CHANGE REQUEST

⌘ **23.012 CR 015** ⌘ rev **4** ⌘ Current version: **5.2.0** ⌘

Title:	⌘ Addition of ADD feature		
Source:	⌘ Ericsson L.M., Siemens, Telefonica, T-mobile		
Work item code:	⌘ TEI6	Date:	⌘ 11/03/2004
Category:	⌘ B	Release:	⌘ Rel-6
	<i>Use one of the following categories:</i> F (correction) A (corresponds to a correction in an earlier release) B (addition of feature), C (functional modification of feature) D (editorial modification) Detailed explanations of the above categories can be found in 3GPP TR 21.900 .		<i>Use one of the following releases:</i> 2 (GSM Phase 2) R96 (Release 1996) R97 (Release 1997) R98 (Release 1998) R99 (Release 1999) Rel-4 (Release 4) Rel-5 (Release 5) Rel-6 (Release 6)

Figure 4.1.3.1 (sheet 2 of 3): Process Update_Location_HLR

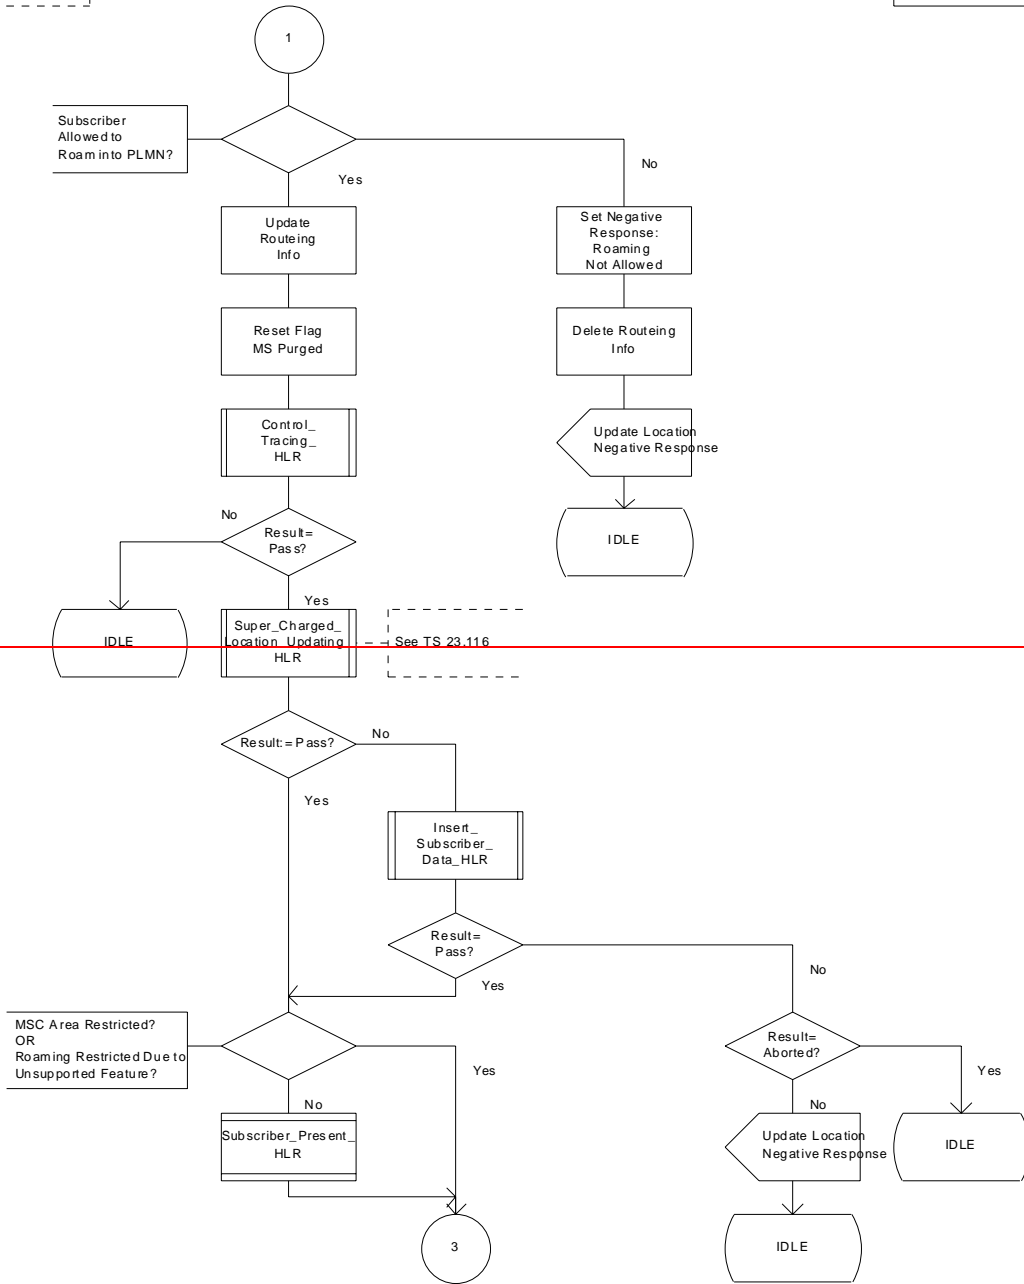
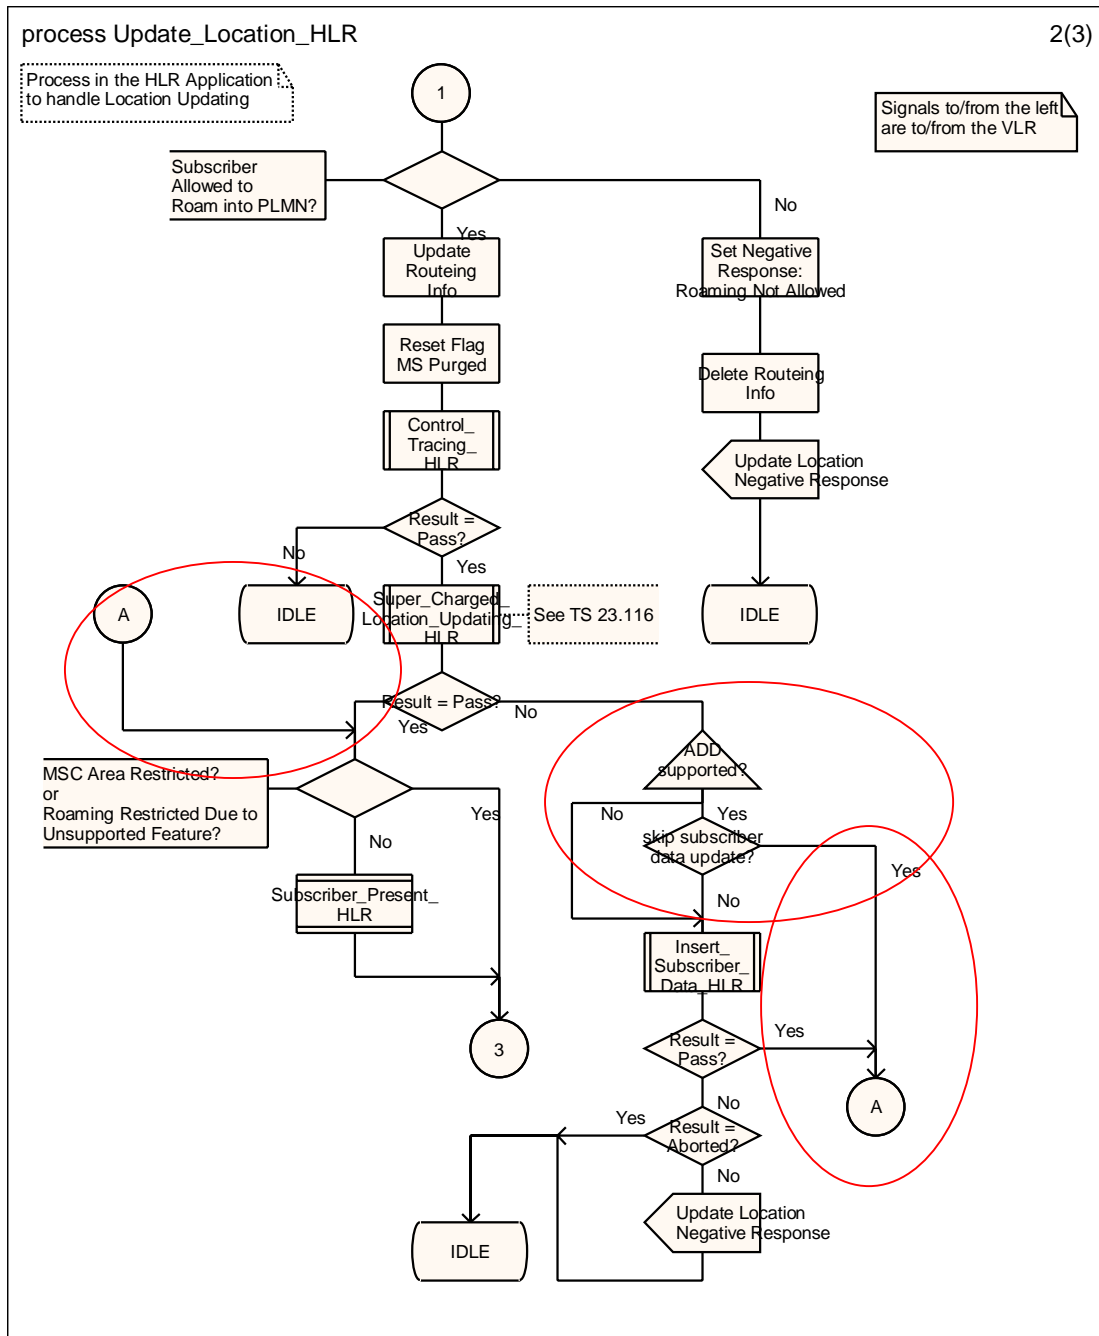
Sheet 2: The execution of the test "skip subscriber data update?" is optional and depends on the presence of the relevant indication from the VLR. If no indication is received, then the result of the test is "No".
